RESOURCE CONSERVATION AND RECOVERY ACT FACILITY INVESTIGATION ZONE K
SOLID WASTE MANAGEMENT UNIT 166 TREATABILITY STUDY CNC CHARLESTON SC

**ZONE K
SWMU 166 TREATABILITY STUDY
WORK PLAN**

RESPONSE TO COMMENTS FOR

**DRAFT ZONE K
SWMU 166 TREATABILITY
STUDY WORK PLAN**

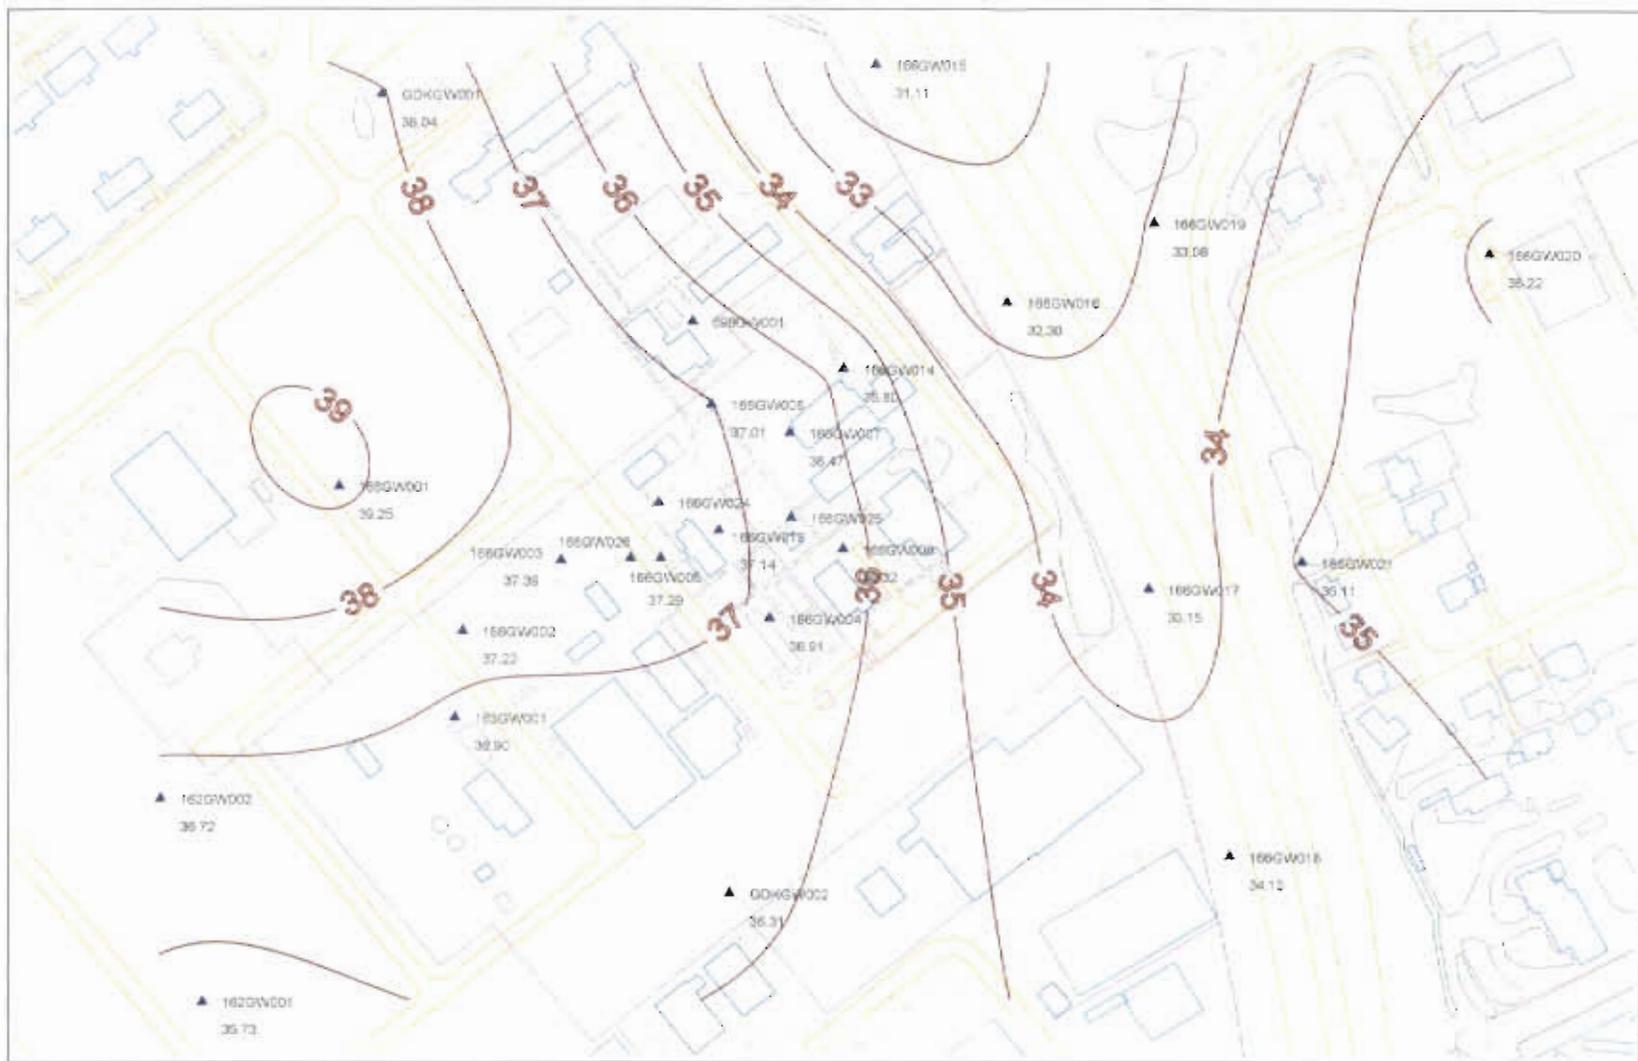
Figures 1.2 and 1.3 ... these figures are not complete, fill material is shown, what fill material?, litho as presented appears homogeneous, legend does not match figure symbols, is this a Zone F cross section?, does this consider the most recent data available? Please correct to accurately portray site cross-section conditions.

Figures 1.2 and 1.3 has been replaced by a figure taken from the Zone K RFI (Figure 2.5). This figure differentiates between the upper and lower units of the shallow aquifer and provides greater detail than the figure presented in the draft TS WP.

Figure 1.4
Deep (20 - 30 B56) Piezometric Contours
March 1998

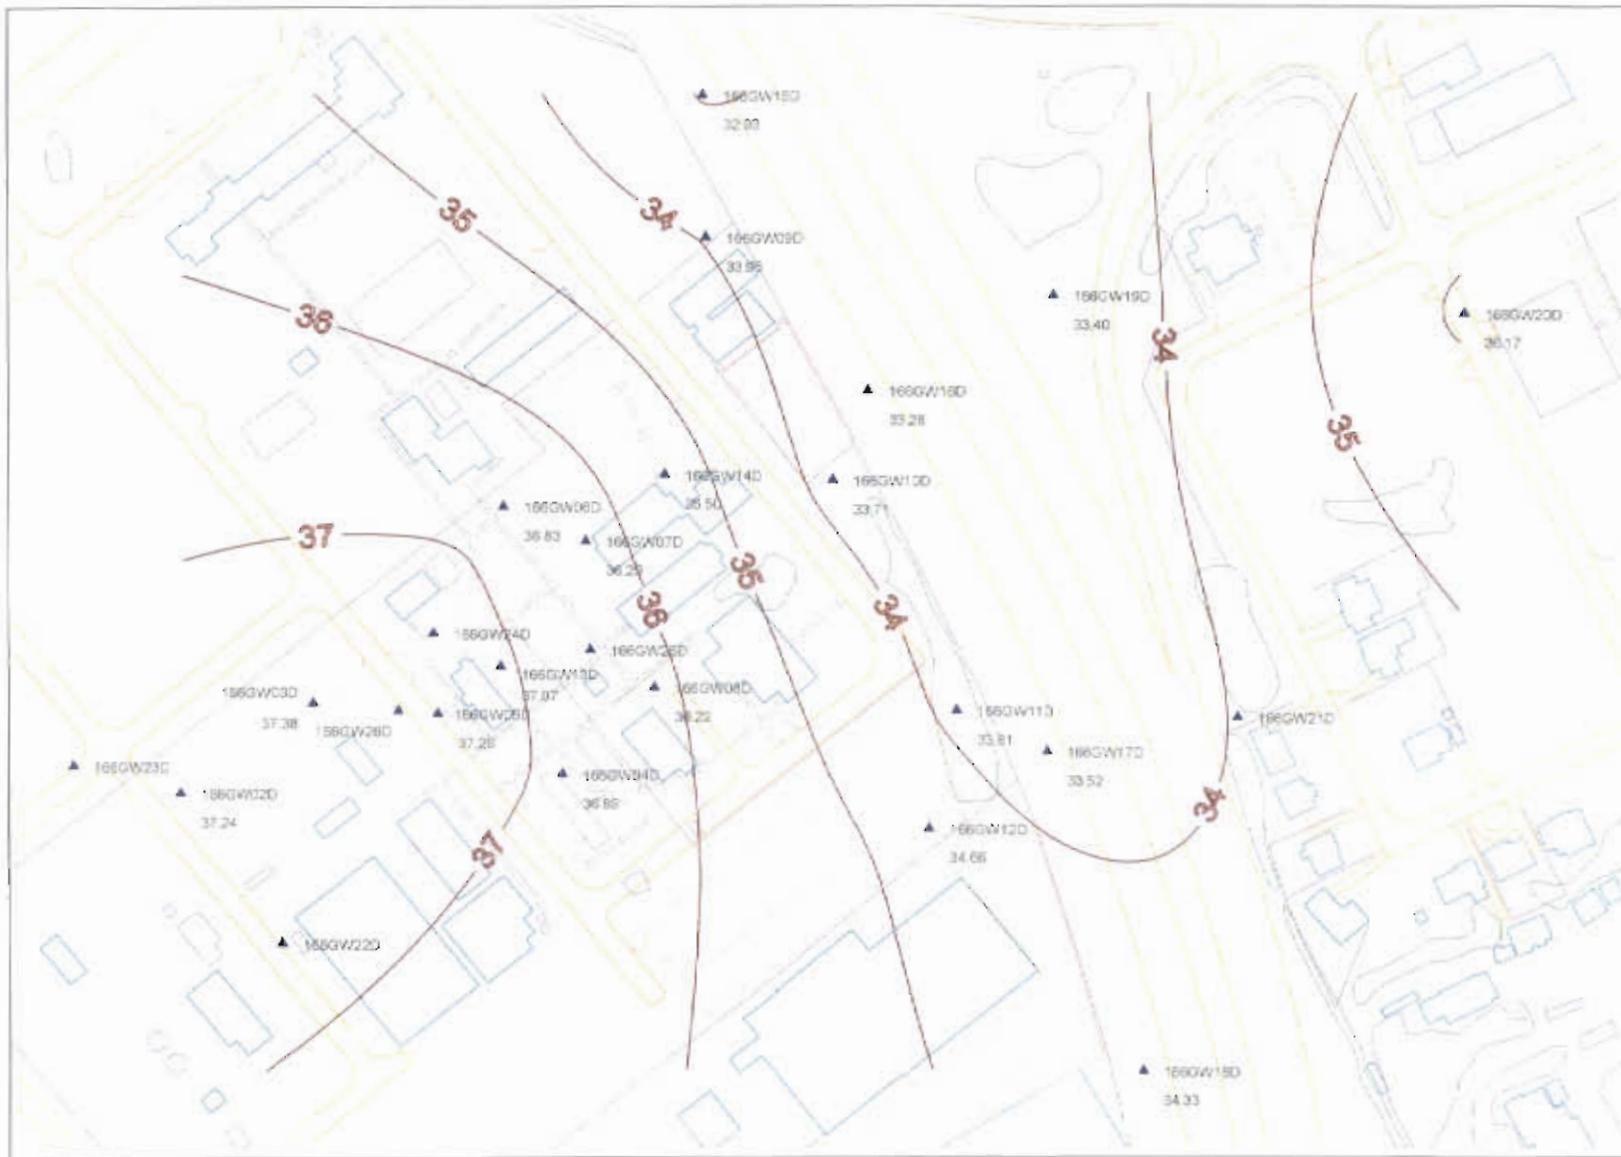
Figures 1.4 and 1.5 ... we would like to see more (and most recent) potentiometric contours ...

is the GW flow direction, as shown in the TS, constant and representative of current site conditions?

Figures 1.4 and 1.5 have been renumbered to Figures 1.3 and 1.4. Additional potentiometric maps were generated using data collected in January, 1999. This data has been contoured and is shown on figures 1.5 and 1.6.
